TECHNICAL SERVICE BULLETIN

Distribution To: General Distribution
TSB Number: 250501
Date: 01/05/2025
Product Brand: Narva
Product Category: LED Lighting

**Issue:**

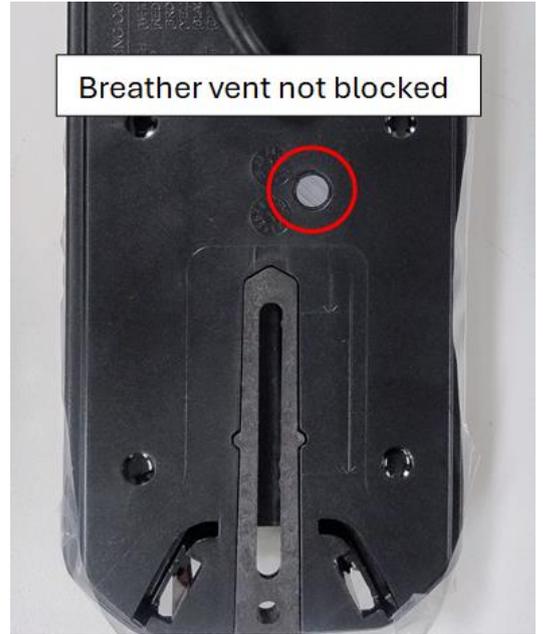
There's potential of the tail lamps having condensation/water ingress if the breather vent is blocked.

Investigation on the lamps with water ingress showed that the breather vent at the back of lamp was blocked with silicon during fitment onto the flat panel surface of vehicle.

The purpose of the breather vent is to allow moisture going in/out of the lamp. If it's blocked, condensation will build up.

Ensure that the breather vent is not blocked or sealed during fitment.
